Access Compliance Report

Public Rights-of-Way

Intersection ID: 28238	Main Street: ADDINGTON_CT	Cross Street: DARBY_CHASE_DR	Location: NW
ADA ID: EC5CC328491D	Ramp Type: Perp	Initial Pass/Fail: Fail	Overall Compliance: No
			Severity Score: 36.25

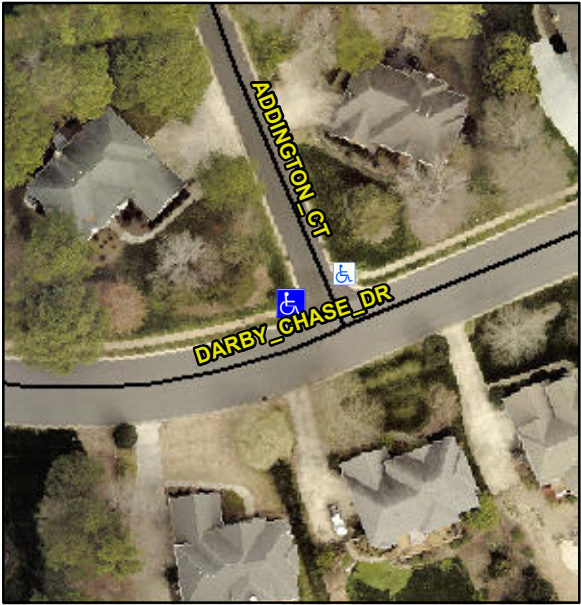
Codes/Mitigation Info/Possible Solution			Field Measurements/Component Compliance		
	Possible Solutions:		Compliance	Description	Data
	Remove & Replace Entire Ramp.		Yes	Ramp Length (in)	55.5
			No	Ramp Width (in)	26.0
			N/A	Flare Type LT	N/A
			N/A	Flare Slope LT (%)	N/A
			N/A	Flare Traversable LT?	N/A
			N/A	Landing Length (in)	N/A
			N/A	Landing Width (in)	N/A
			N/A	Landing Slope (%)	N/A
			N/A	Landing X Slope (%)	N/A
<p>Surveyor Notes:</p> <p>N/A</p> <p>PROW/ADA:</p> <p>Not Found, R304.5.1, R304.5.3</p>			N/A	Flare Type RT	N/A
			N/A	Flare Slope RT (%)	N/A
			N/A	Flare Traversable RT?	N/A
			N/A	DWS Provided?	N/A
			N/A	DWS Contrast?	N/A
			N/A	DWS Length (in)	N/A
			N/A	DWS Full Width?	N/A
			N/A	DWS Offset (in)	N/A
			N/A	Gutter Ponding?	N/A
			N/A	Gutter Lip Ht (in)	N/A
			No	Painted X Walk1?	N/A
				X Walk 1 Direction	To NE
			N/A	X Walk 1 Width (in)	N/A
				X Walk 1 Slope (%)	2.2
				X Walk 1 X Slope (%)	2.4

N/A	Ramp inside XWalk1?	N/A
			N/A	Road Slope (%)	N/A
			N/A	Road X Slope (%)	N/A
			N/A	Any Obstructions?	N/A
				Obstruction Type	
Total Cost:					
					\$ 1850.00
			N/A	Clear Space?	N/A
			N/A	Clear Space to XWalk (in)	N/A
			N/A	Storm Grate/Utility Hazard?	N/A
				Storm Grate/Utility Type	
			N/A		N/A
			Yes	Surface Condition? (G/P)	Good
